D.L. ATCHISON SUBDIVISION

APPLICATION NUMBER 8 DATE August 20, 2009

DETAIL SITE PLAN

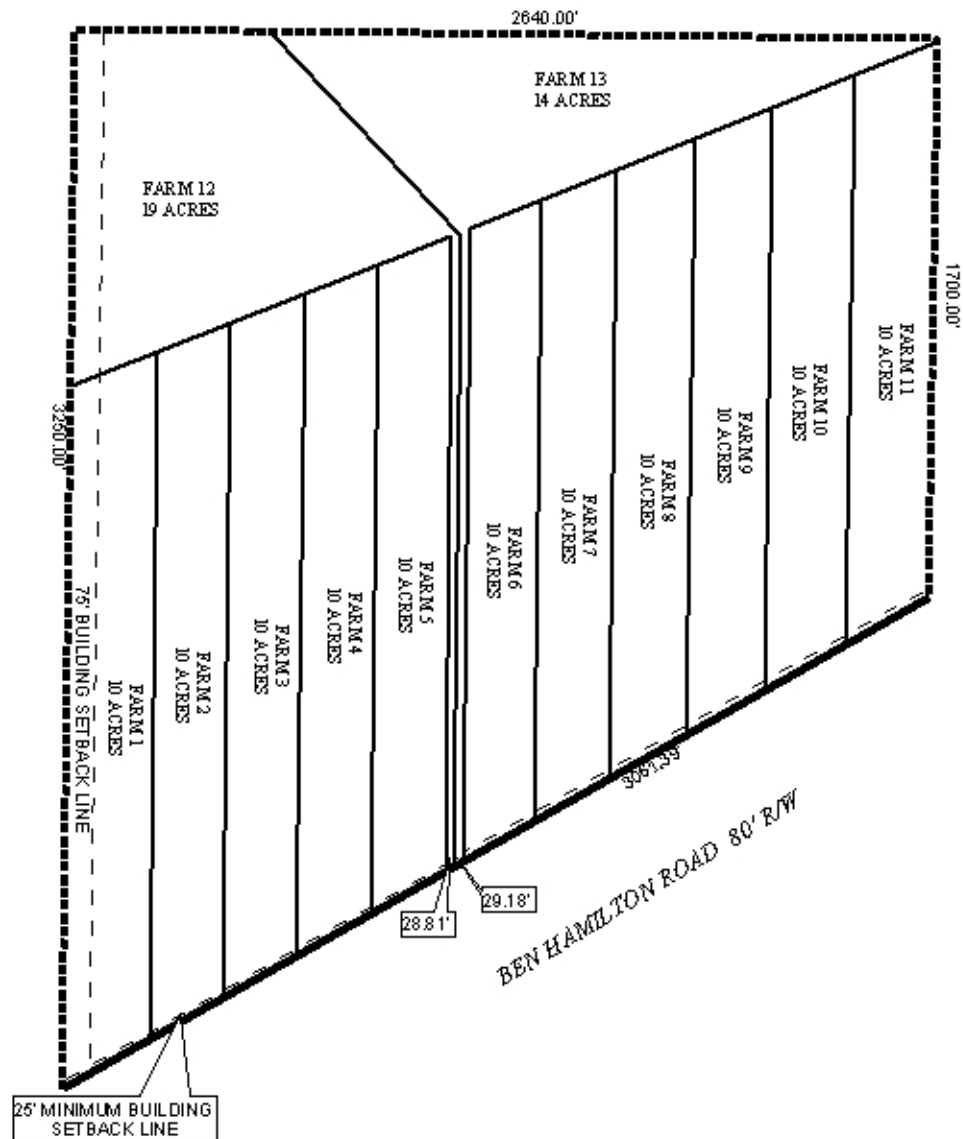
As proposed, Lots 1-10 have 260' – 300' of frontage along Ben Hamilton, while Lots 11 and 12 are flag lots with 25' of frontage each. If approved, a note should be placed on the final plat stating that each lot is limited to one curb cut to Ben Hamilton Road, with the size, location, and design to be approved by County Engineering and in conformance with AASHTO standards.

As mentioned, Lots 11 and 12 are flag lots. Section V.D.1 of the Subdivision Regulations states that “panhandle or flag lots shall generally not be allowed, but may be permitted only in those locations where varied and irregularly-shaped designs are common and the informality of design is consistent with other lots in the vicinity; or, where unusual circumstances such as an odd shaped lot exists; or, separate disparate uses exist on a single lot; or, where there are natural or pre-existing man-made barriers which may cause an undue hardship on the land owner; or in the case of a family division.” None of the aforementioned scenarios pertain to this application. In any event, the “poles” are over 1900' in length, hardly characteristic of any flag lot approved by the Commission in the past. Furthermore, there are no existing lots in the vicinity that would justify proposed Lots 1-10, which exceed the maximum depth allowance of Section V.D.3 of the Subdivision Regulations. The maximum depth of lots shall be 3.5 times the width; the applicant is proposing lots with ratios over 7.5.

However, if approved, the applicant should illustrate a 25' minimum building setback line on all lots (along Ben Hamilton Road); on Lots 11 and 12, the setback line shall be from where the “poles” meets the “flag” portions of the lots. Also, if approved, a note should be placed on the final plat stating that no future subdivisions of Lots 11 and 12 will be allowed until additional frontage on a public street is provided.

The plat meets the minimum size requirement for developments with access to public water and individual septic tanks. However, if approved, it is requested that the applicant revise the preliminary plat to label the lots with their sizes in square feet, or provide a table on the plat with the same information.

The site is located in the county. Therefore, if approved, a note should be placed on the final plat stating that any lots developed commercially and adjoin residentially developed property must provide a buffer, in compliance with Section V.A.8 of the Subdivision Regulations.

- 1) the plat does not comply with Section V.D.1 or V.D.3 of the Subdivision Regulations.
